SOUTH CAROLINA ELECTRIC & GAS COMPANY

Subject: Virgil C. Summer Nuclear Station  
Docket No. 50/395  
Operating License No. NPF-12  
Spent Fuel Pool Rerack Modification

FIG. 2-1 MODULE LAYOUT

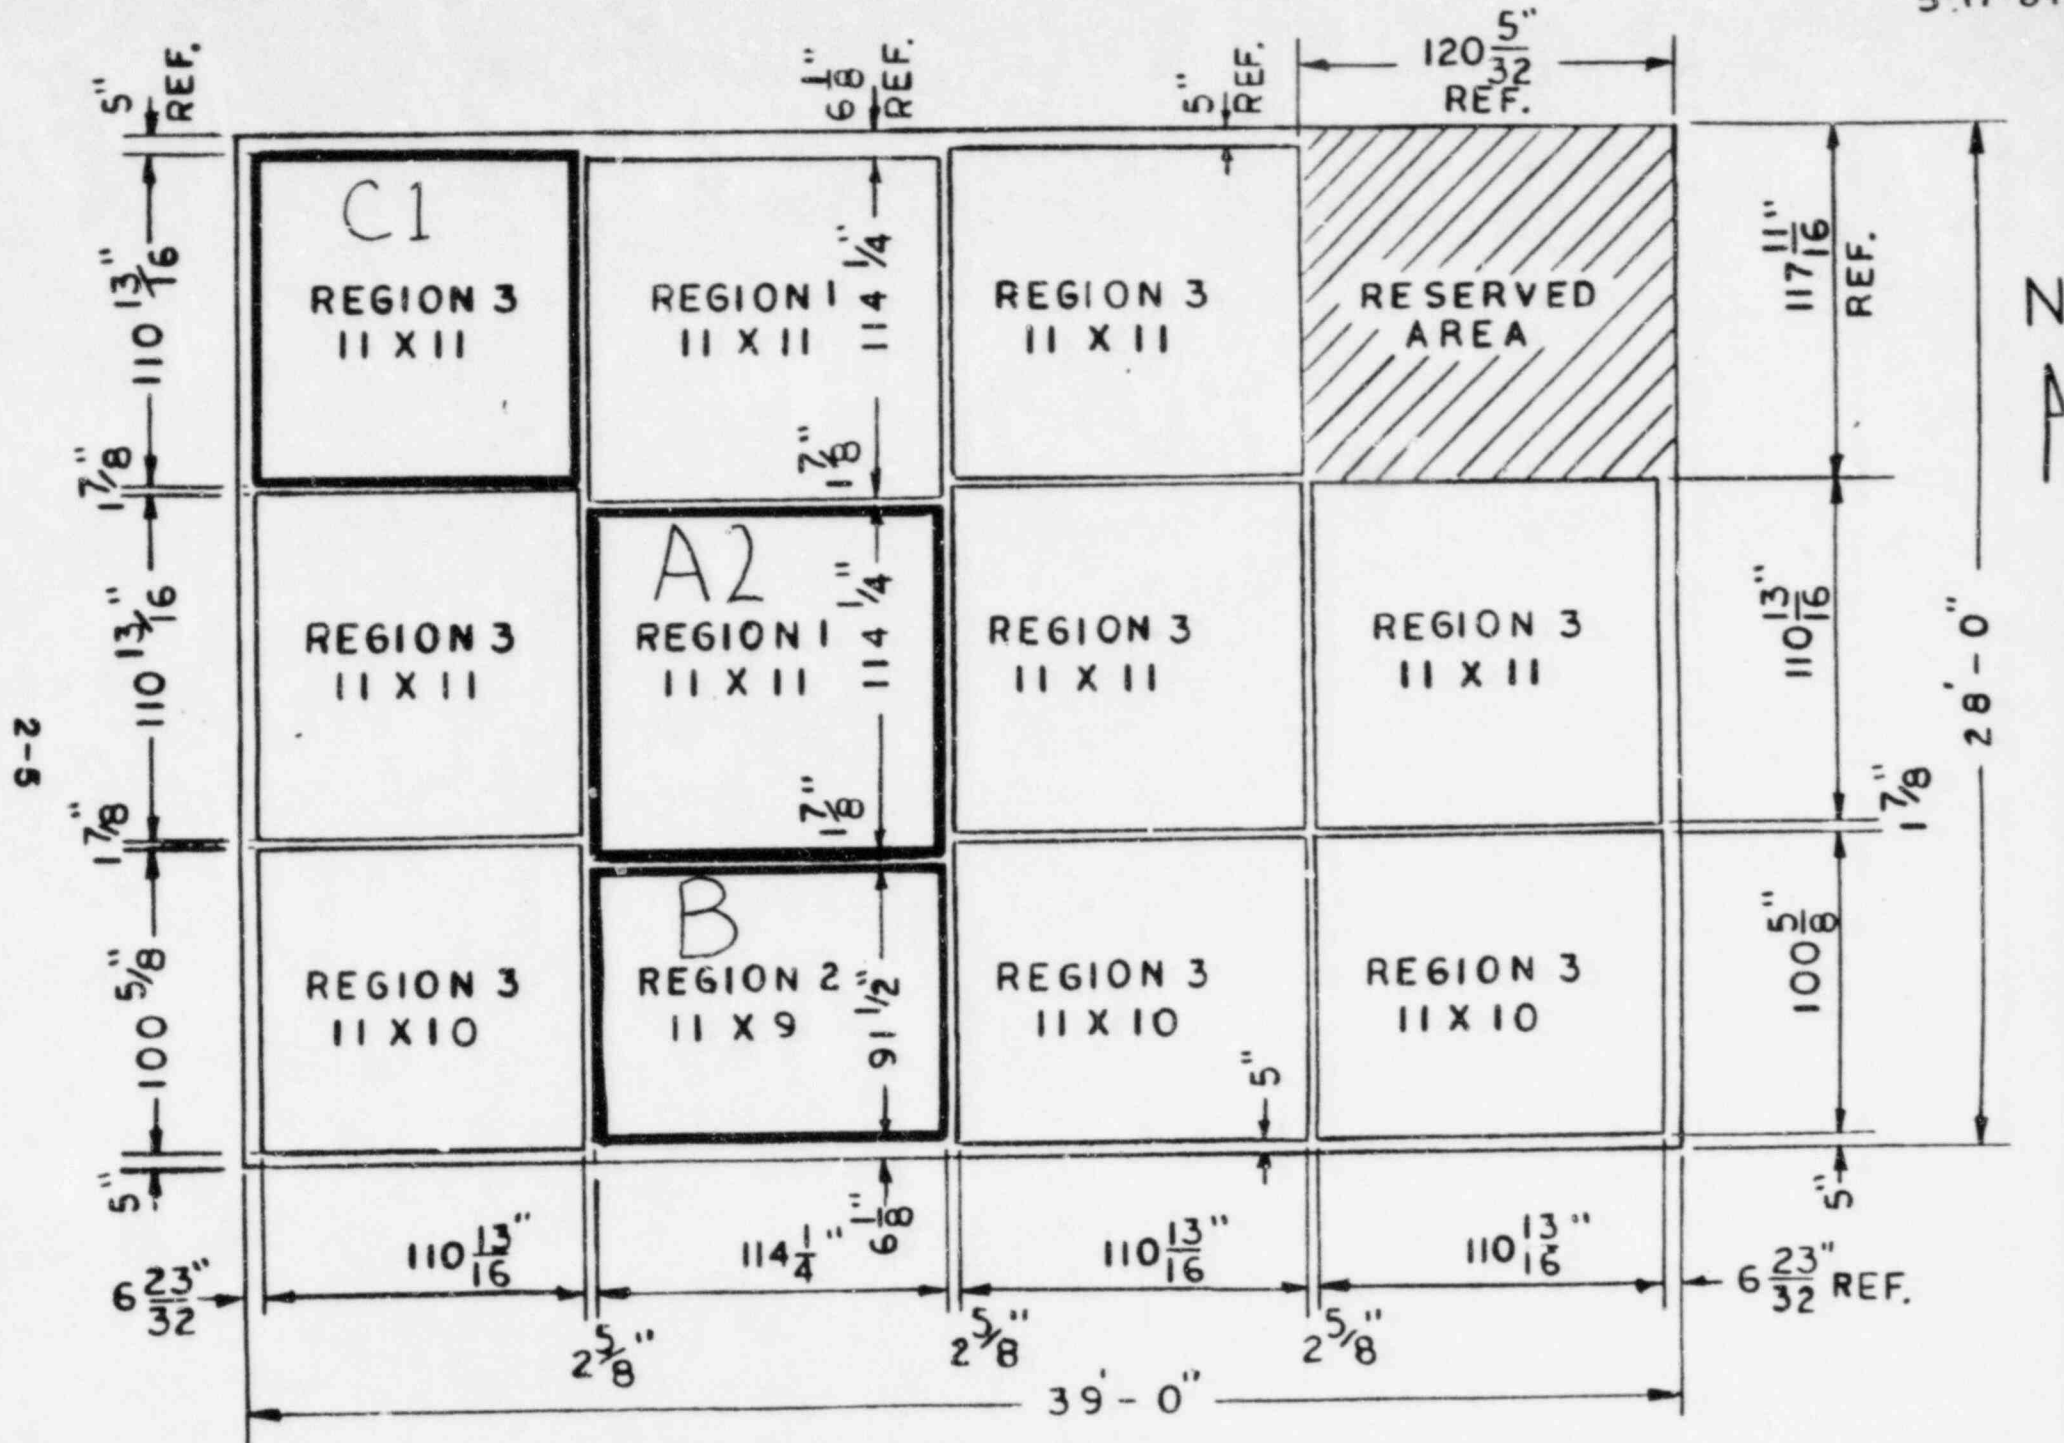
The third question asks for further clarification on which modules were seismically analyzed supplemented by more detail on the analysis results. Detailed analyses were performed on racks A2 and C1 (see attached Figure 2.1). These were the largest modules and representative of the different types of

STRUDL MODEL (NORTH-SOUTH)

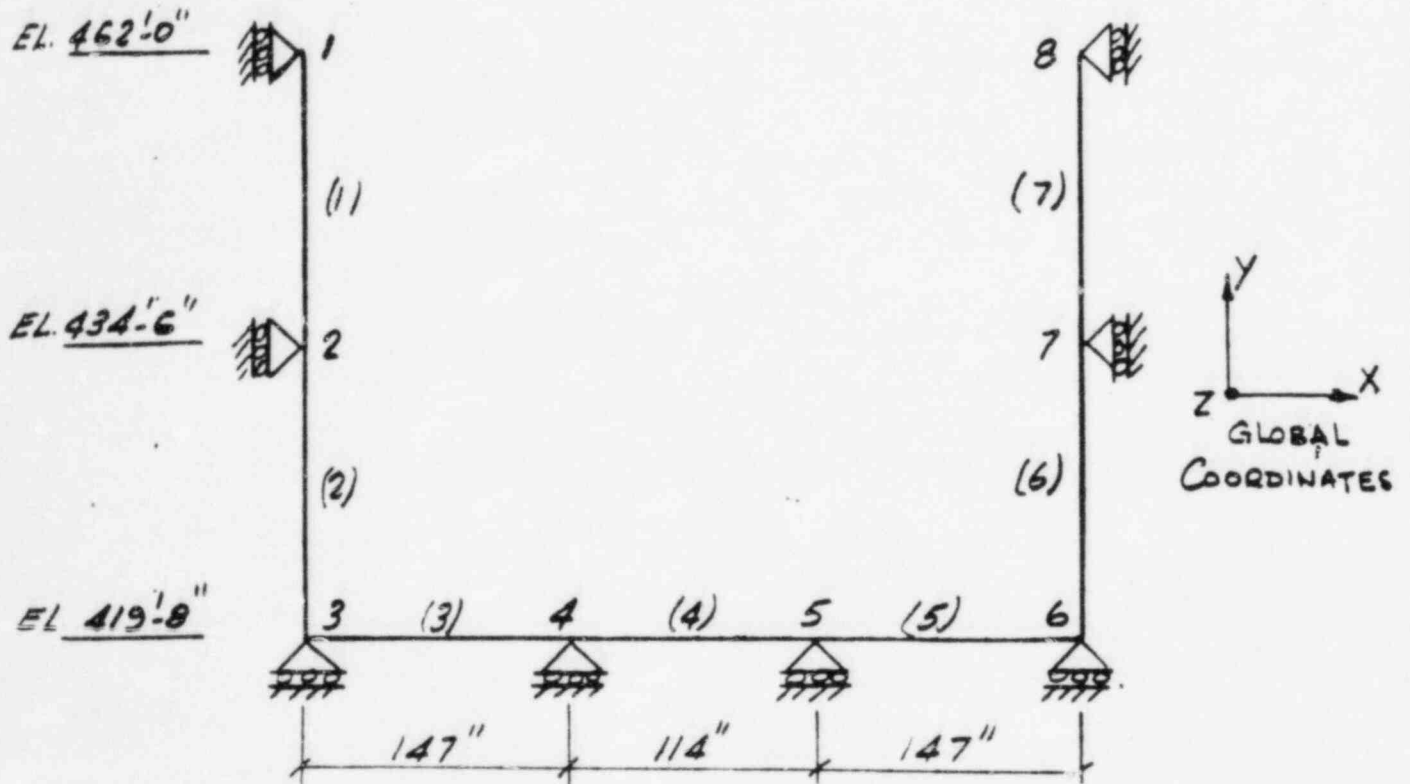
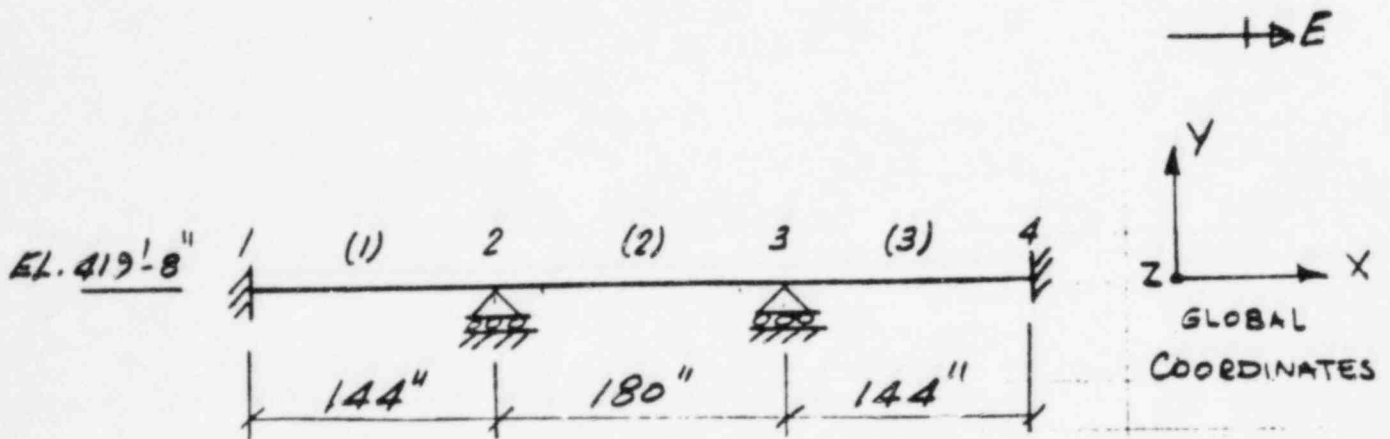
The seventh question requests information on the model and computer code used for the spent fuel pool structural analysis. The computer code used for the re-evaluation of the pool structure under the new rack loading is "Inhouse McAuto ICES STRUDL, GAI Program #S110 Revision 3," certified to Gilbert Associates' Computer Application Manual (CAM). The models used for this analysis are shown on the enclosed attachments 4 and 5. The beam strip theory was considered to be a conservative analysis method because of the thickness of the slab in relation to the span and column width.
